**STAFF REPORT**  
**COMMUNITY DEVELOPMENT DEPARTMENT**

HEARING DATE: 11/18/2021  
 TO: Mayor & City Council  
 FROM: Alan Tiefenbach  
 208-884-5533  
 SUBJECT: AZ, PP - H-2021-0074  
 Jamestown Ranch Subdivision  
 LOCATION: Parcels S0434223150, S0434212970, S0434212965, S0434212920, and 4023 W. McMillian Rd, located at the southeast corner of the N. Black Cat / W. McMillian Rd intersection.

Annexation with the R-8 zoning district, and preliminary plat to allow 294 building lots and 25 common lots on 80.3 acres of land.

C. Color Landscape Plan with Recommended Pathway Connections (date: 9/9/2021)

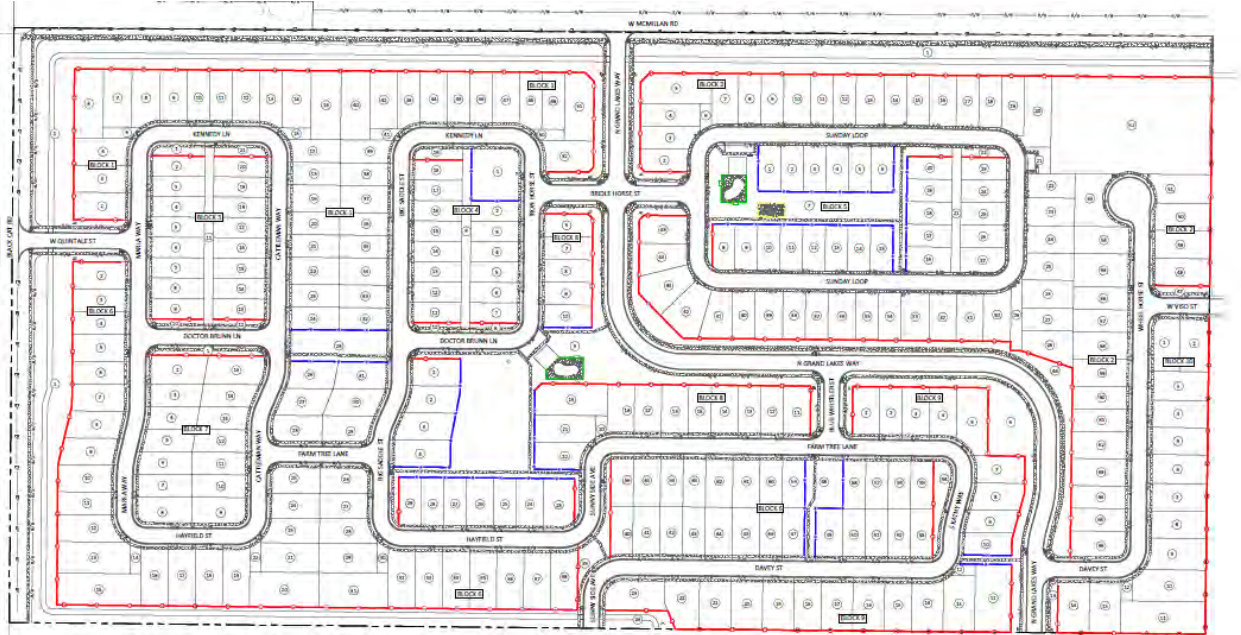
*Staff does believe there are portions of the development where there could be more direct non-motorized connectivity to the amenities and common open space within the development as well as to the detached sidewalk along N. Black Cat Rd. Staff has red-marked these recommended connections on the landscape plan below.*

A 10 ft. wide detached pathway is reflected along W. McMillian Rd. which is consistent with the alignment shown on the Pathways Master Plan. There is also a 10 ft. wide detached pathway along one side of N. Grand Lakes Way. (the internal collector) which connects to the W. McMillian Rd. pathway. Several micro-pathways are reflected providing connectivity to internal portions of the development. As mentioned in the Comprehensive Plan analysis above, to improve more direct pedestrian connectivity, staff is recommending additional micro-pathway connections (red-marked on the landscape plan below).

- b. All pathways and micropathways shall be within a separate common lot or easement as required per UDC 11-3A-8.
  3. Prior to final plat, the Landscape Plan included in Section VI, dated 9/9//21, shall be revised to reflect the red-marked pathway connections as illustrated in Exhibit D.
